Subject:        Submittal of License Amendment Request #3 to HI-STORM 100 CoC

Attachment 2: Proposed CoC Changes in Markup Format – Deletions are shown in strikeout.  
                  Insertions are marked by vertical bars in the right margin.

Document ID: 5014568

**Figure 2.1-1  
Fuel Loading Regions - MPC-24**

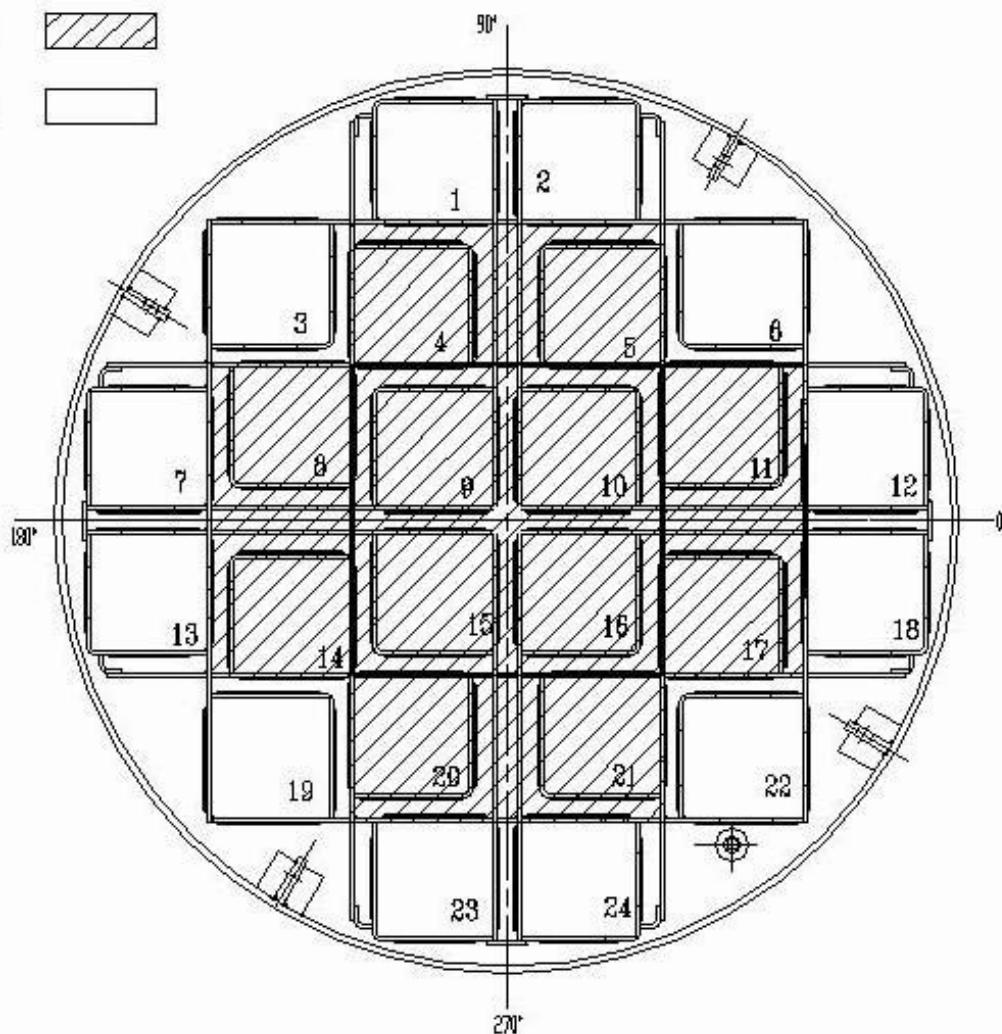
- e. Appendix B, Figure 2.1-1 and 2.1-2 – Increase number of storage locations in Region 1 of 24-assembly MPC designs to reflect new regionalized loading scheme.
- f. Appendix B, Section 2.4 – Update Table 2.4-1 to reflect increase in the design basis maximum decay heat loads. Update Table 2.4-2 and the associated discussion to reflect the new decay heat regionalizing scheme that is part of the increase in the design basis maximum decay heat loads.
- g. Appendix B, Table 2.4-3 – Update coefficients to reflect the increase.
